Access Compliance Report

Public Rights-of-Way

(Curb Ramps)

Intersection ID: 1002095	Main Street: J_W_CLAY_BV	Cross Street: N/A	Location: W
ADA ID: 7B021F772249	Ramp Type: Perp	Initial Pass/Fail: Fail	Overall Compliance: No
		Severity Score: 8.75

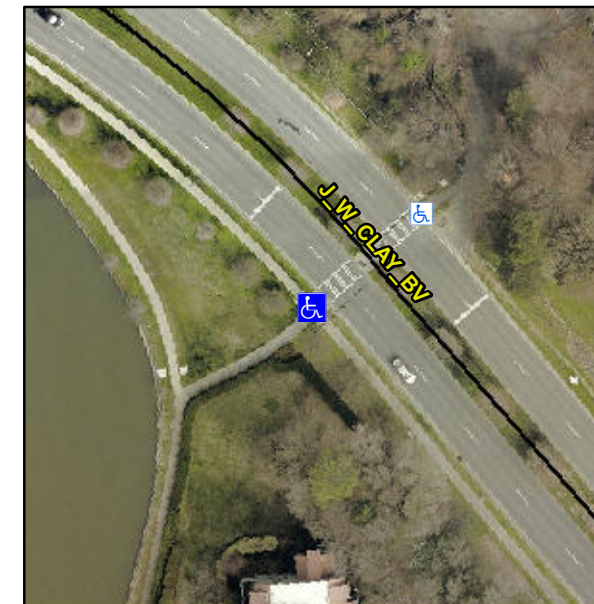
Not Found, R304.5.1

Compliance	Description	Data	Compliance	Description	Data
N/A	Ramp Length (in)	55.0	Yes	Ramp Slope (%)	8.1
No	Ramp Width (in)	43.0	Yes	Ramp XSlope (%)	1.2
N/A	Flare Type LT	N/A	N/A	Flare Type RT	N/A
N/A	Flare Slope LT (%)	N/A	N/A	Flare Slope RT (%)	N/A
N/A	Flare Traversable LT?	N/A	N/A	Flare Traversable RT?	N/A
N/A	Landing Length (in)	N/A	N/A	DWS Provided?	N/A
N/A	Landing Width (in)	N/A	N/A	DWS Contrast?	N/A
N/A	Landing Slope (%)	N/A	N/A	DWS Length (in)	N/A
N/A	Landing X Slope (%)	N/A	N/A	DWS Full Width?	N/A
N/A	Landing Curb? (Y/N)	N/A	N/A	DWS Offset (in)	N/A
N/A	Shared Landing?	N/A			
N/A	Gutter Ponding?	N/A	N/A	Gutter Slope (%)	N/A
N/A	Gutter Lip Ht (in)	N/A	N/A	Gutter X Slope (%)	N/A
N/A	Painted X Walk1?	Yes	N/A	Painted X Walk2?	N/A
	X Walk 1 Direction	To E		X Walk 2 Direction	N/A
N/A	X Walk 1 Width (in)	110.0	N/A	X Walk 2 Width (in)	N/A
	X Walk 1 Slope (%)	3.5		X Walk 2 Slope (%)	N/A
	X Walk 1 X Slope (%)	2.7		X Walk 2 X Slope (%)	N/A

Remove & Replace Entire Ramp.
